**Applies To:** Series 2 boards (NSC-100, SSP-D2) and Series 3 boards including the SSP-LX when communicating with OSDP readers.

**Issue:** Series 2 and Series 3 controllers may have issues communicating with OSDP readers.

### SSP-LX Diagram

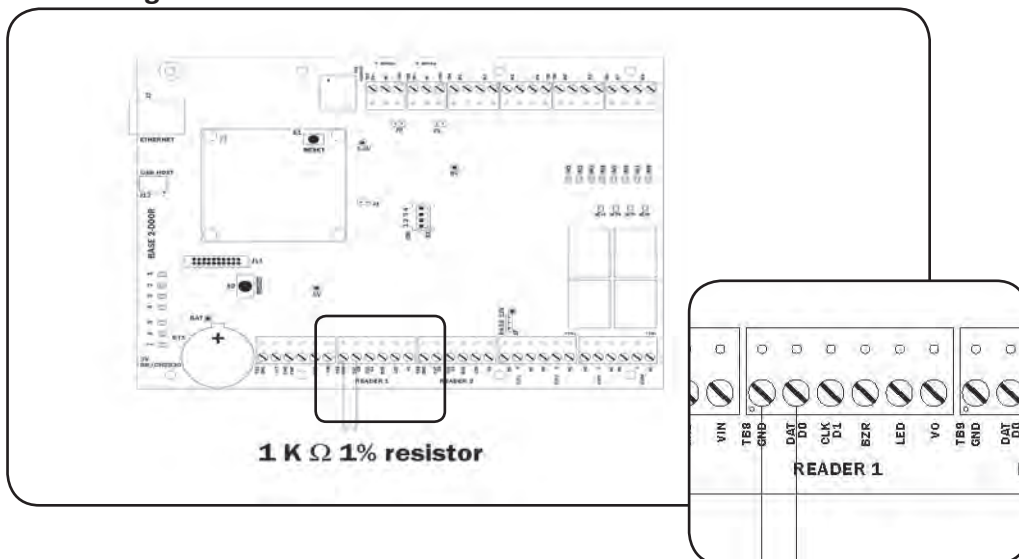
**Summary:** The OSDP readers are interpreting a non-driven 485-line as data in certain installation environments. This interpretation results in a communication fault that will inhibit the panel and reader from properly communicating.

- Place a **1K ohm( $\Omega$ ) 1% resistor** between DAT D0 and GND line

This will create a communication bias that will keep the reader from improperly interpreting data. To function properly, there must be **NO** ground faults in the installation.

**Note:** Please ensure that the DC Ground (power supply return) is **NOT** connected to the earth ground.
